TOWN OF DELAFIELD PLAN COMMISSION MEETING

Tuesday, August 2, 2022, 6:30 p.m.

Plan Commission Report for August 2, 2022

TOY BOX - LYNNDALE ROAD
TOWN OF DELAFIELD, WISCONSIN

SITE PLAN C1.0

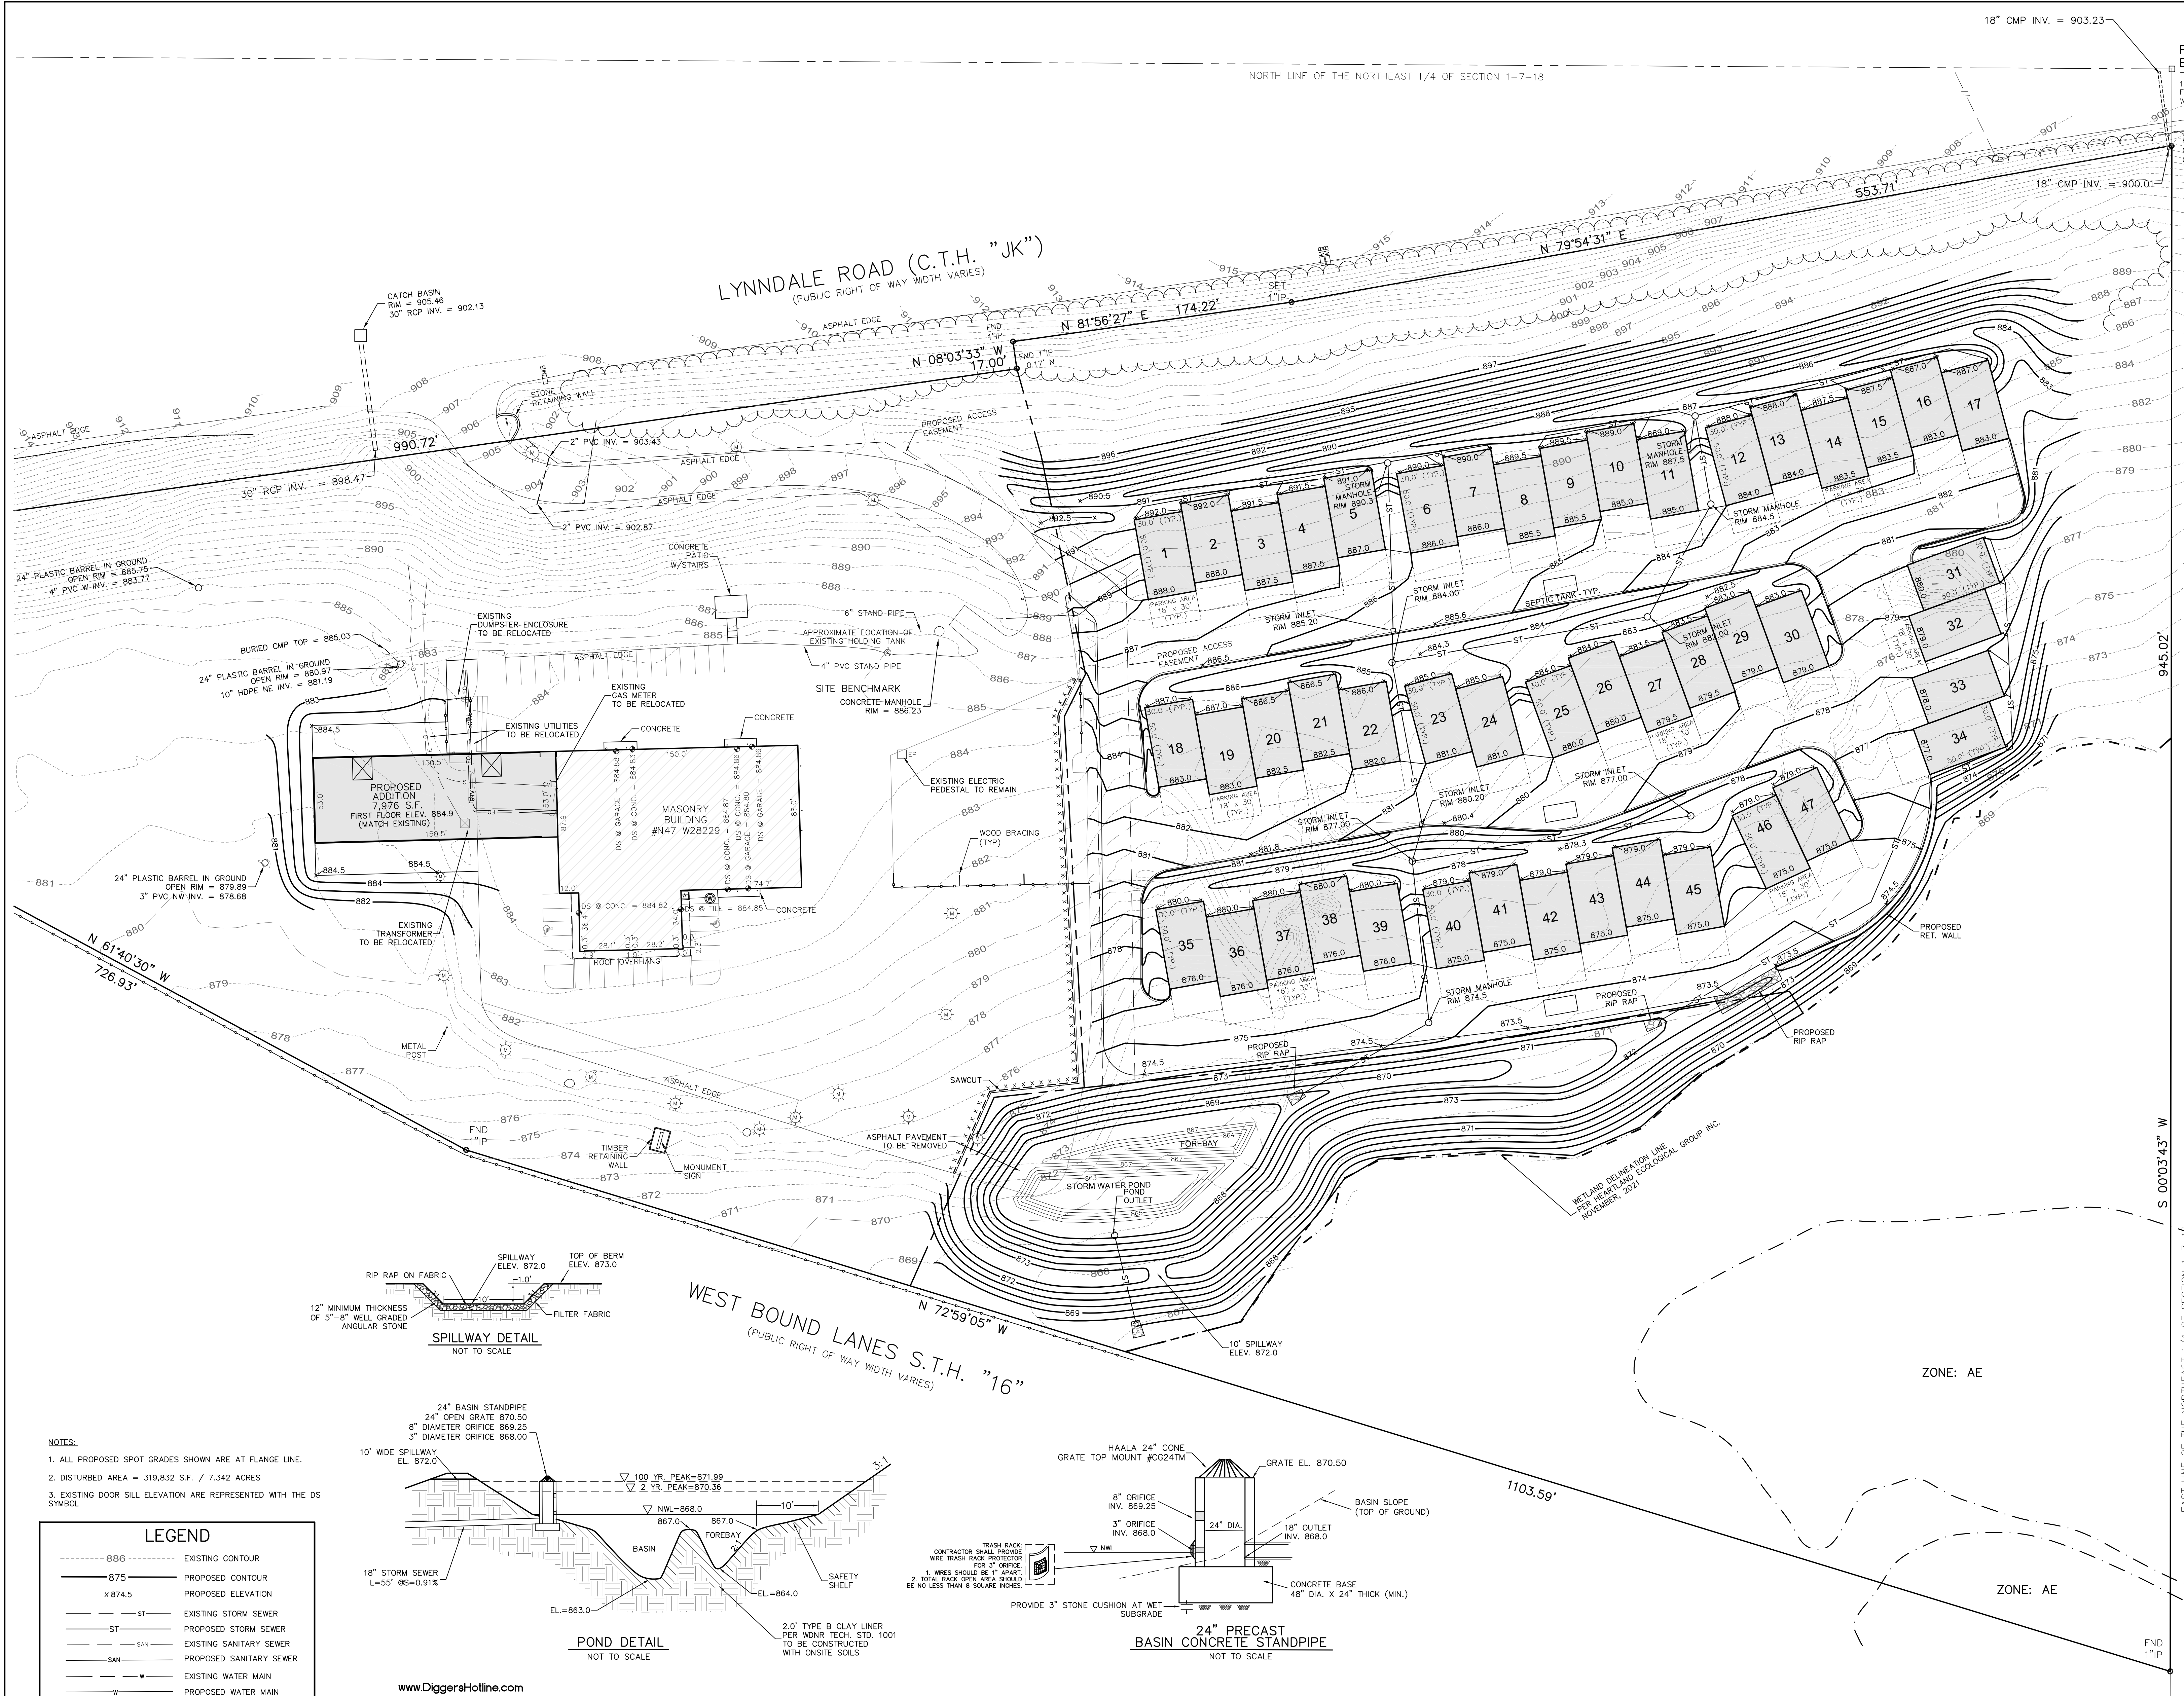
16. The Town is in the process of developing an outdoor lighting ordinance. That ordinance states that the total installed lumen limit is 2.5 lumens per square foot of hardscape. Sheet C1.0 indicates that Lot 2 has 90,586 square feet of paved surface; thus the maximum amount of lumens allowed is 226,465 lumens. The proposed lighting fixtures indicate the total amount of lumens to be 324,000.

Sheet C1.0

1. Include a vicinity sketch.
Response: Vicinity map has been provided on C1.0
2. Include name and address of property owner
Response: Name and address of current property owner has been provided on the site plan.

SITE GRADING PLAN **C2.0**

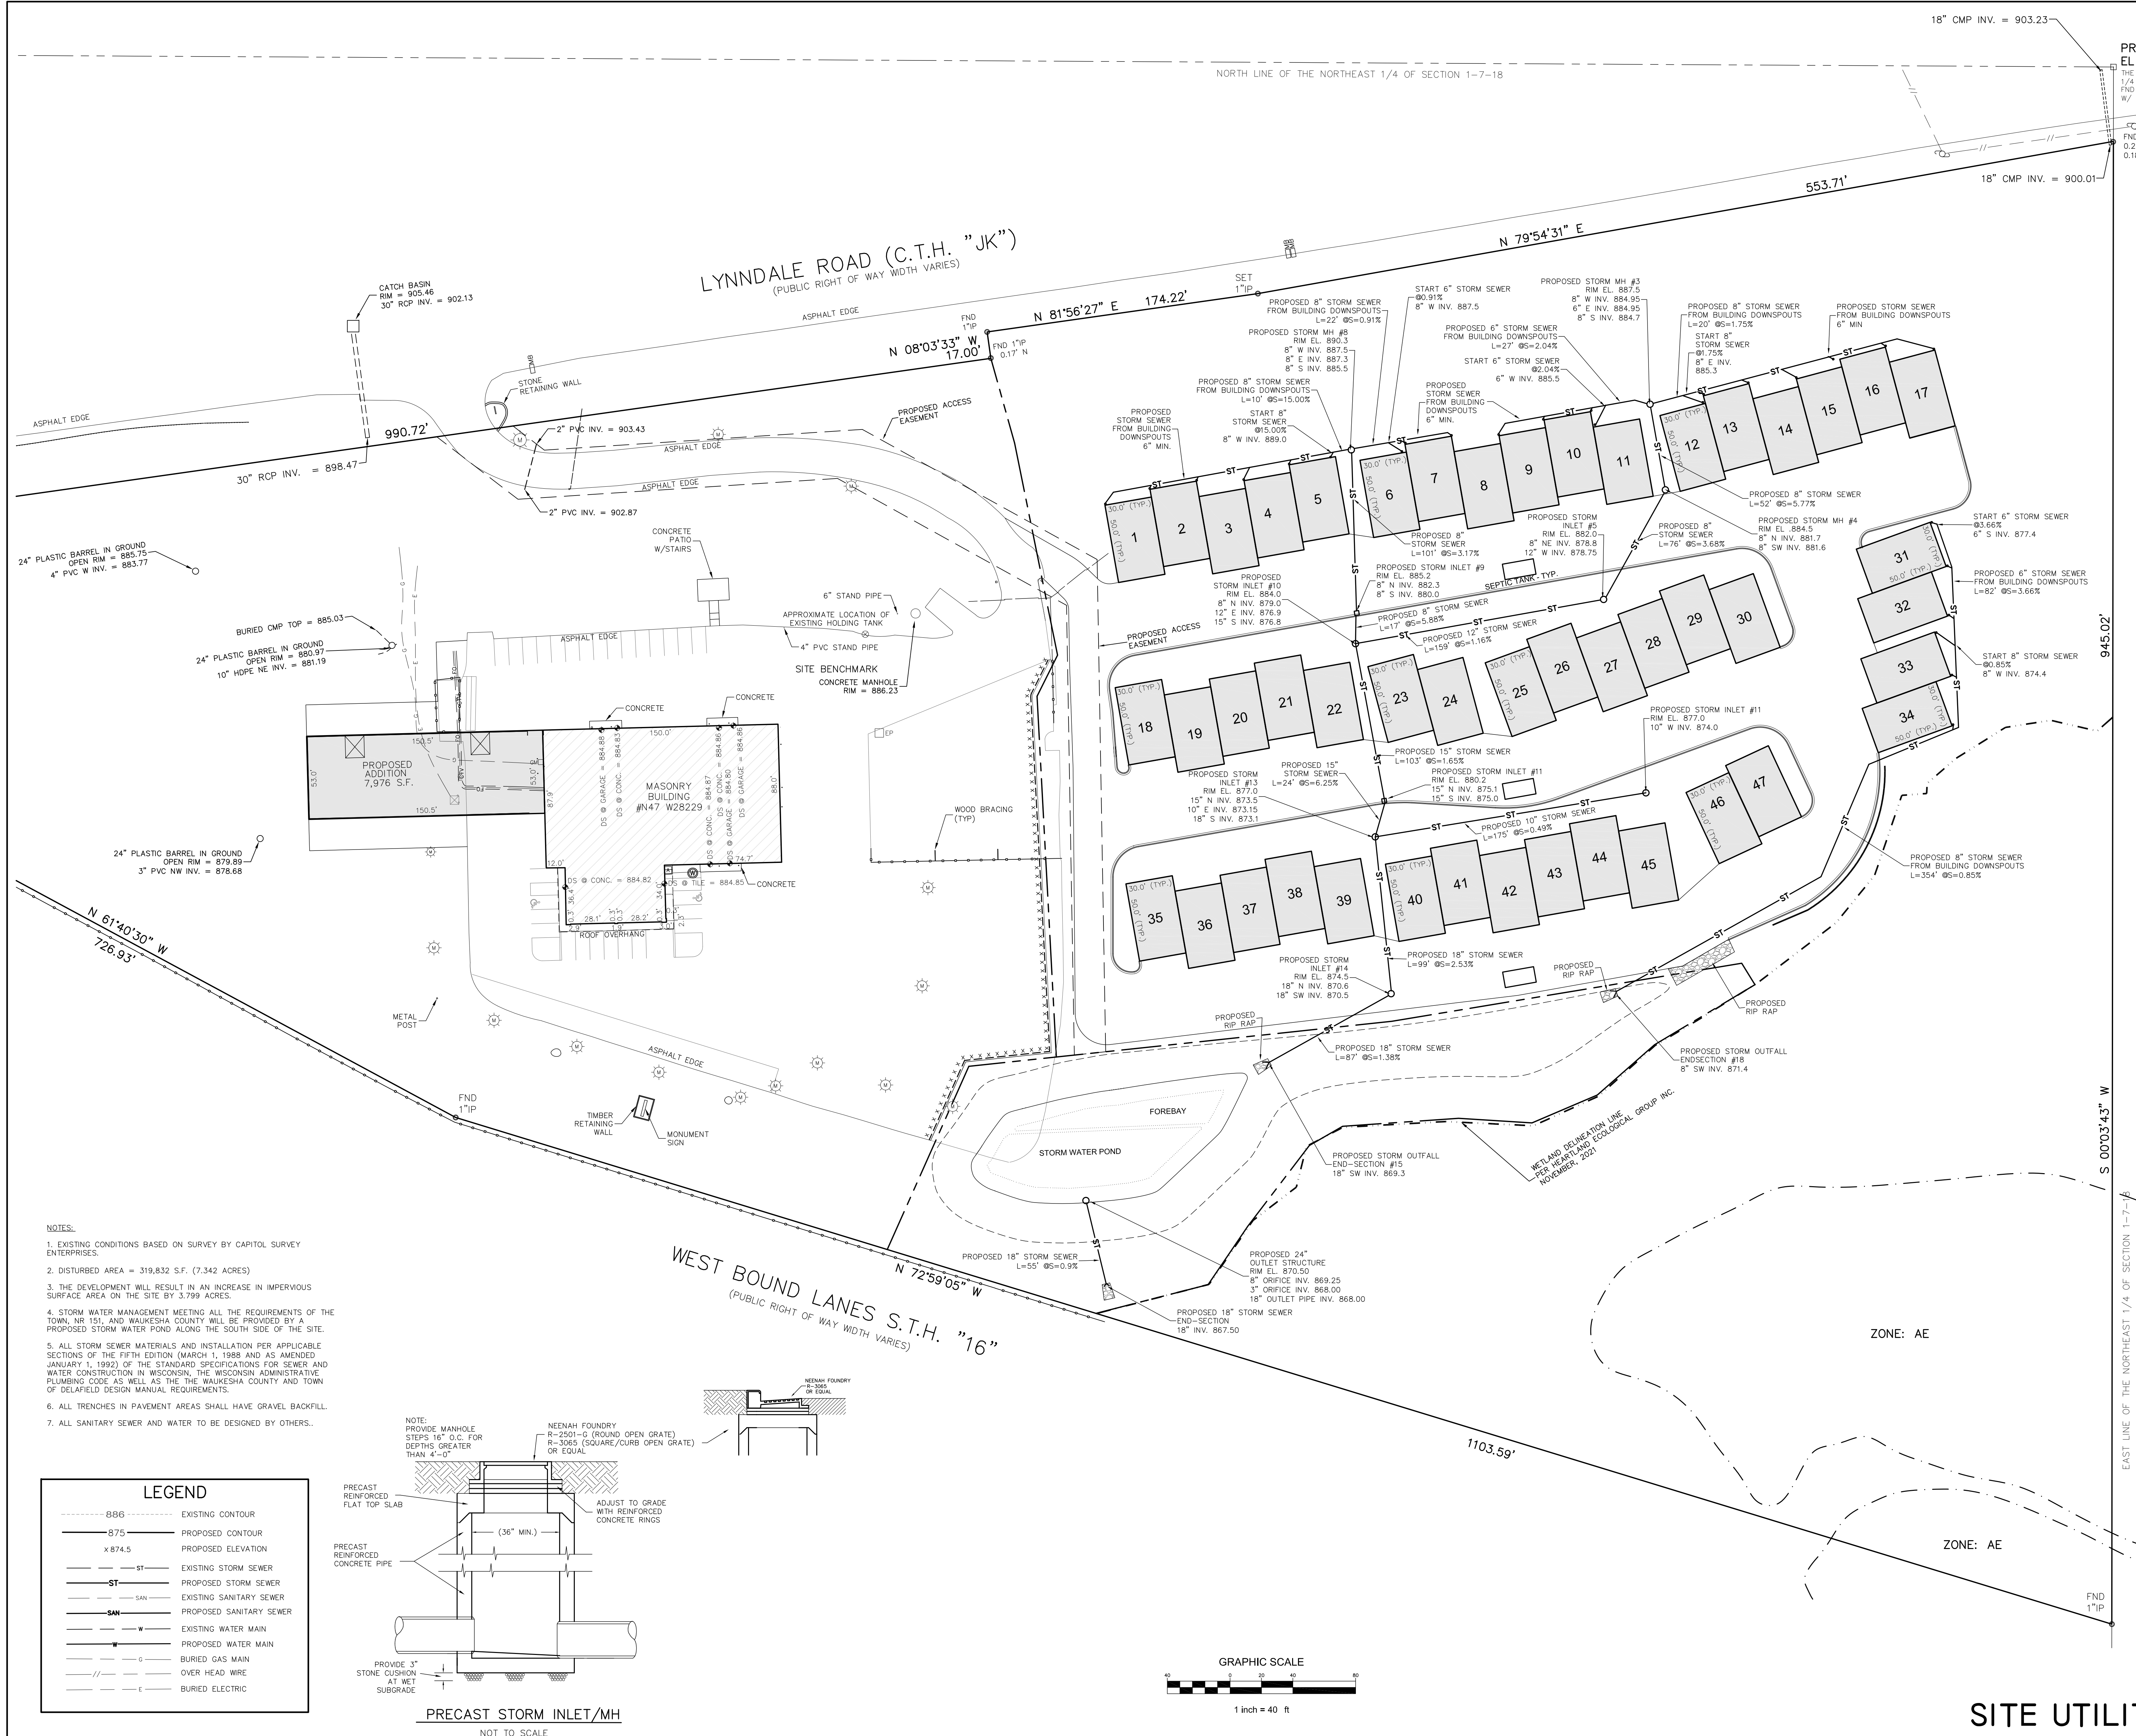
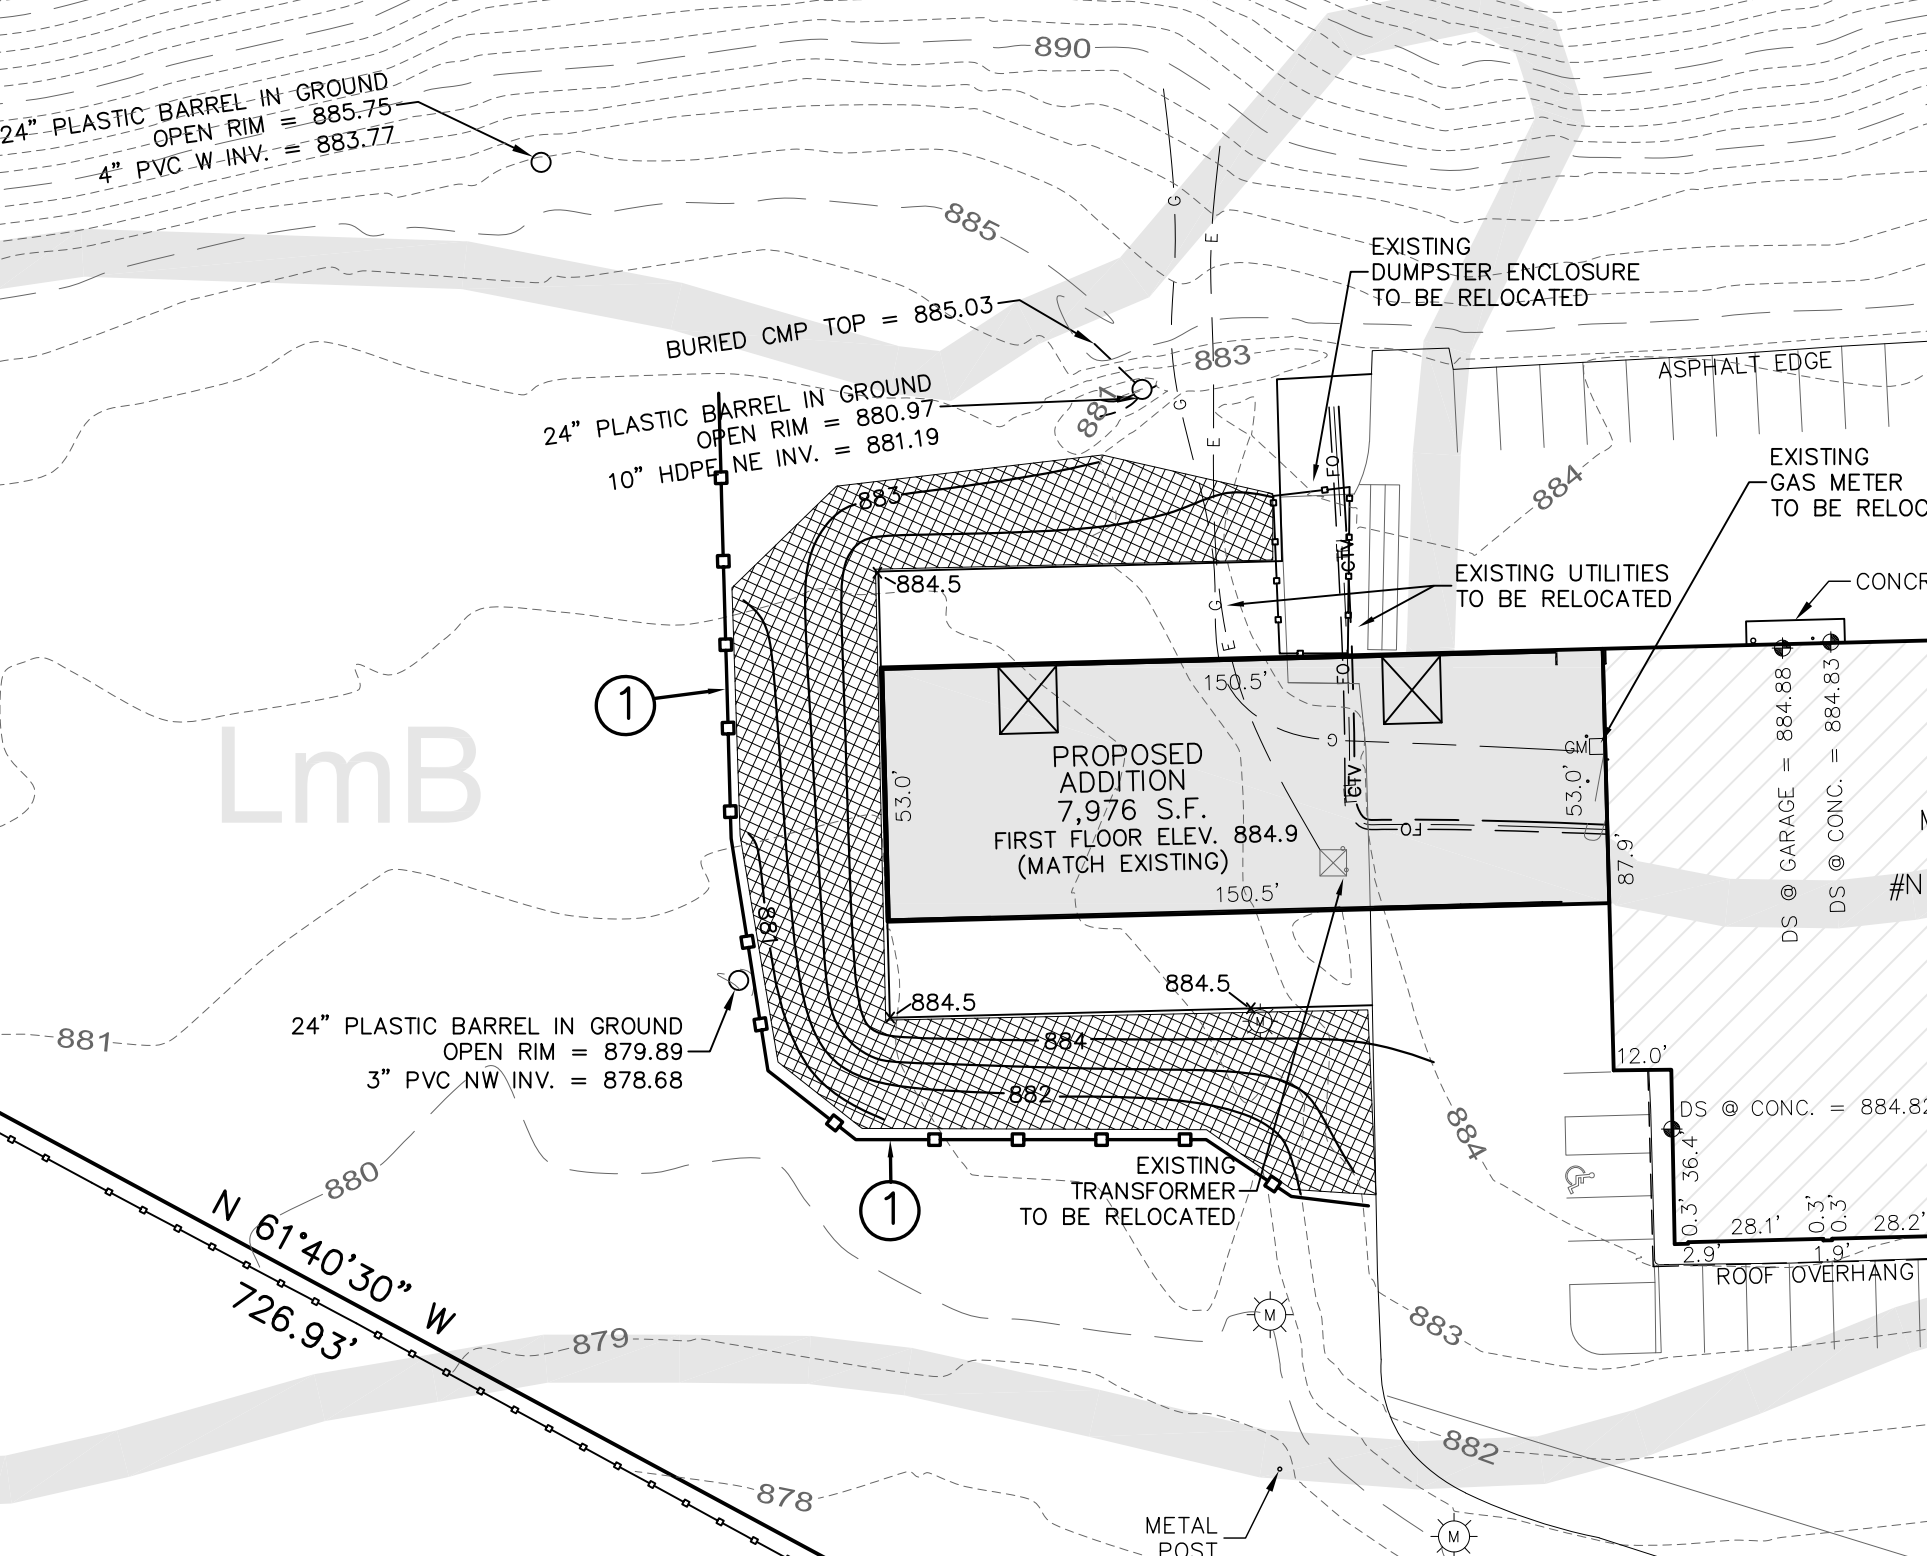
Sheet C2.0
